[Docket No. FAA-2012-0807; Directorate Identifier 2011-NM-191-AD]

Airworthiness Directives; Airbus Airplanes

ACTION: Supplemental notice of proposed rulemaking (NPRM); reopening of comment period.

Figure 1 to paragraph (i)(7) of this AD – Design A of the Passenger Oxygen Containers Affected by this AD

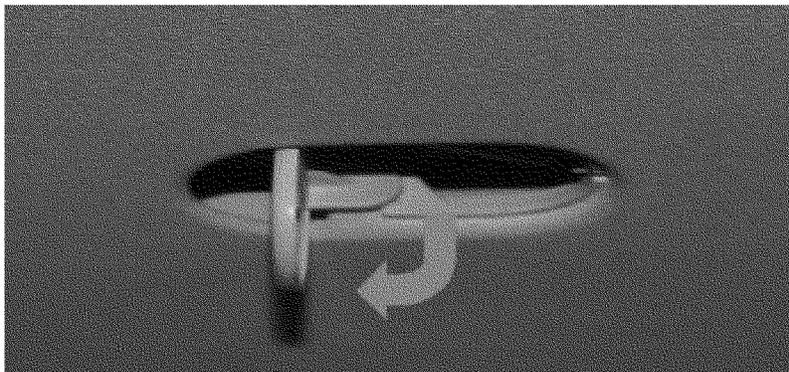
(7) The requirements of paragraphs (g) and (h) of this AD apply only to passenger oxygen containers that are Design A, as defined in figure 1 to paragraph (i)(7) of this AD.

Design A: The placard on the passenger oxygen container test button is as described in Picture A of Appendix 1 of this AD. The Mask configuration ("ZZ" in Picture A) is a number and the test button is as shown in Picture B.
